Response to Highways Comments.

Project name: Wykham Park Farm, Banbury
Author: JB/ KE
Date: 23 December 2022
Project number: P21 – 2662
Reference: Response to Highways Comments

Persimmon (South Midlands) are progressing a reserved matters application at Wykham Park Farm, Banbury for 237 dwelling, Ref: 22/O2068/REM for OS parcel 7400 adjoining and south of Salt Way, Bodicote, Banbury. Following submission of an initial internal layout, comments were received from Oxfordshire County Council (OCC) Highways Officer on 5th December 2022 by email relating to the proposed layout.

Extract 1

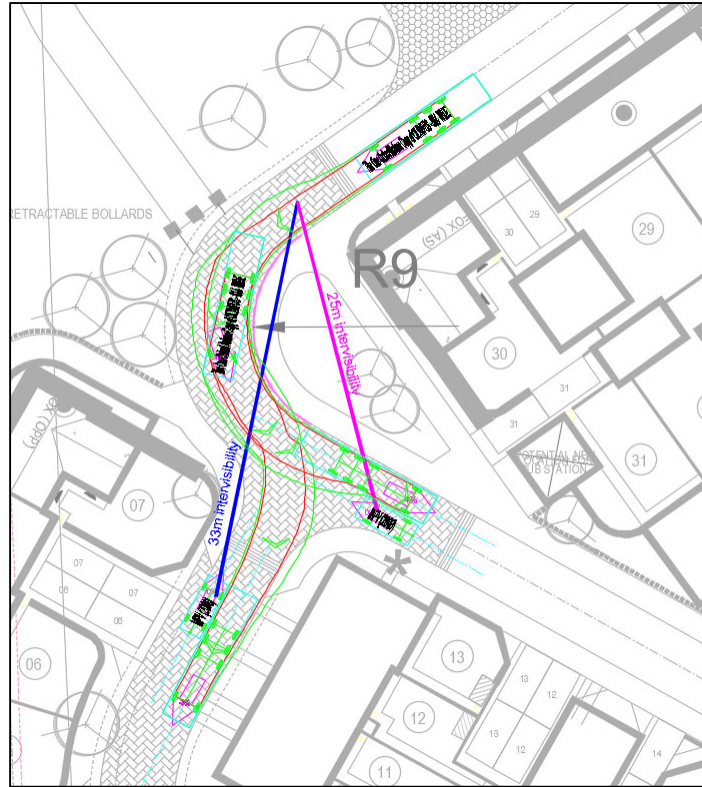
OCC require a swept path analysis for an 11.6m in length refuse vehicle passing an on-coming or parked family car throughout the layout. The carriageway will require widening on the bends to enable this manoeuvre.

At the focal junction between plots 30, 07 and 11 intervisibility is achieved between a car and refuse vehicle approaching the bend or junction allowing vehicles to stop and wait if a vehicle is oncoming. The northern arm of the junction serves only six dwellings and therefore is anticipated to be associated with very low trip generations. Extract 1 below demonstrates that a car/ refuse vehicle can wait at a point where vehicles can pass one another with visibility to the next point where vehicles can return to the correct side of the carriageway. The intervisibility distance shown are 33m to the southern arm and 25m to the eastern arm which are equal to or greater than the visibility requirement of 25m for a 20mph residential layout such as this (Manual for Streets guidance). The land on the inside of the bends within the intervisibility splay and within the junction visibility splay will be kept free from obstruction and will be dedicated as highway to ensure highways have control of the land such the visibility can be maintained.
